Product Change Notification / ASER-26UKDT173

CCB 4514.001 Final Notice: Qualification of MTAI as an additional assembly site for selected LE96xxx device family available in 36L VQFN (4x6x1mm) package.

CCB 4514.001
Pre and Post Change Summary
Lead Frame Comparison
PCN#: ASER-26UKDT173

Lead Frame Comparison

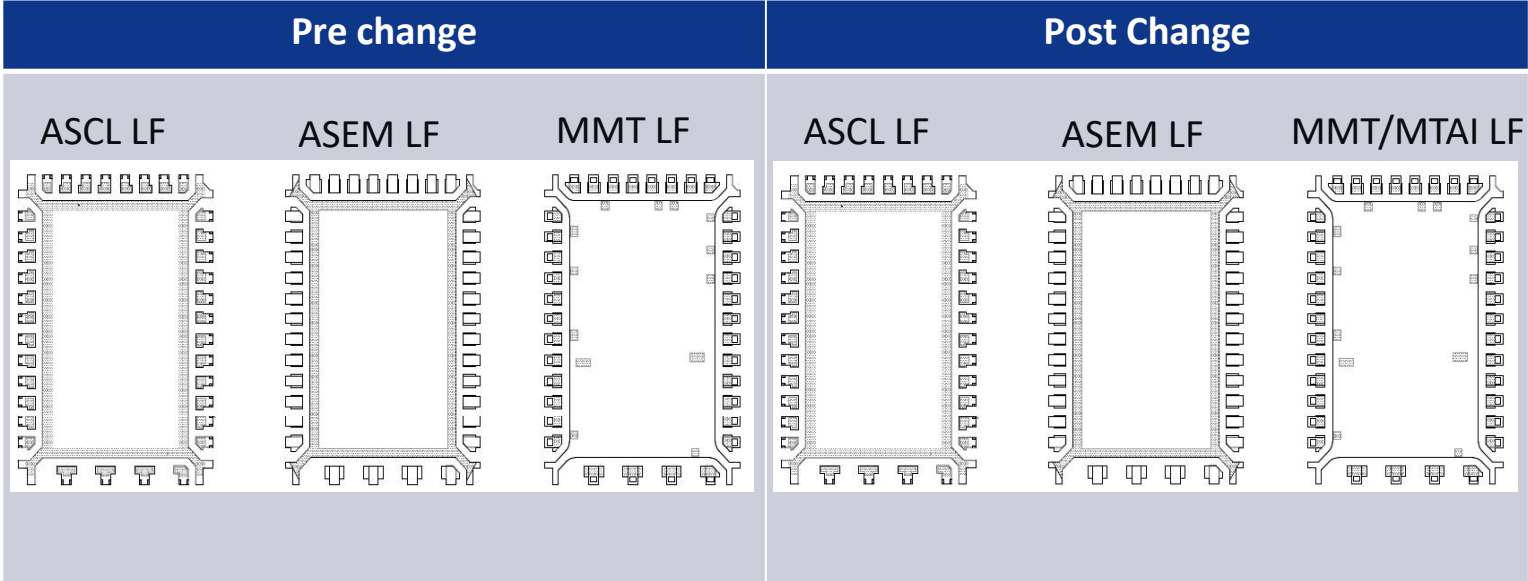
Description of Change:Qualification of MTAI as an additional assembly site for selected LE96xxx device family available in 36L VQFN (4x6x1mm) package.

Pre Change			Post Change			
Assembly Site	ASE Group -Malaysia (ASEM)	ASE Group Chung-Li (ASCL)	Microchip Technology Thailand (MMT)	ASE Group -Malaysia (ASEM)	ASE Group Chung-Li (ASCL)	Microchip Technology Thailand (MMT)	Microchip Technology Thailand (MTAI)

Wire material	CuPdAu	PdCu	CuPdAu	CuPdAu	PdCu	CuPdAu	CuPdAu
Die attach material	CRM1076DS	EN4900	3280	CRM1076DS	EN4900	3280	3280
Molding compound material	CEL-9240HF10A K-G1	G631H-Y	G700LTD	CEL-9240HF10A K-G1	G631H-Y	G700LTD	G700LTD
Lead frame material	C194	C194	A194	C194	C194	A194	A194
DAP Surface Prep	Ag Ring Plated	Ag Ring Plated	Ag selective Plated	Ag Ring Plated	Ag Ring Plated	Ag selective Plated	Ag selective Plated
Lead-Lock	No	No	Yes	No	No	Yes	Yes
See Pre and Post Change Summary for comparison.
